**QUALITY ASSURANCE - NONCONFORMANCE REPORT**

**Location:** SFOBB E2/T1 Foundations

**NCR #**130

KFM LETTERS 230, 234, 238, 239, 240, 241, and 242 – RESPONSE TO METS NCRs 130, 131, 133, 134, 135, 137, 138, 139, 140, 141, 142, and 143

The photograph # 1 below depicts the area where the temperature indicator crayon did not melt on the pile # 3-G.

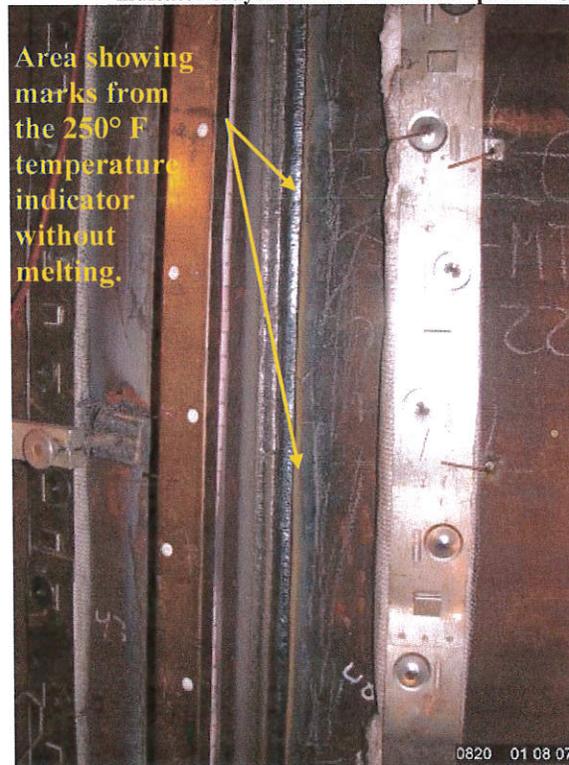
The Contractor failed to maintain the preheat temperature during the welding of several E2 pile head connection plates as required by the Special Provisions, Section 10-1.31, Field Welding of Pile/Sleeve Connector Plates, Line F. The loss in preheat temperature occurred at the following locations: Pile head connection plate 2-G weld 1 and 2 (all around), 3-G weld 3 and 4 (from 0 to approximately 700 mm from the bottom) and 3-H (top area only). The digital photographs below depict the areas where the temperature indicator shows a temperature less than 250°F.
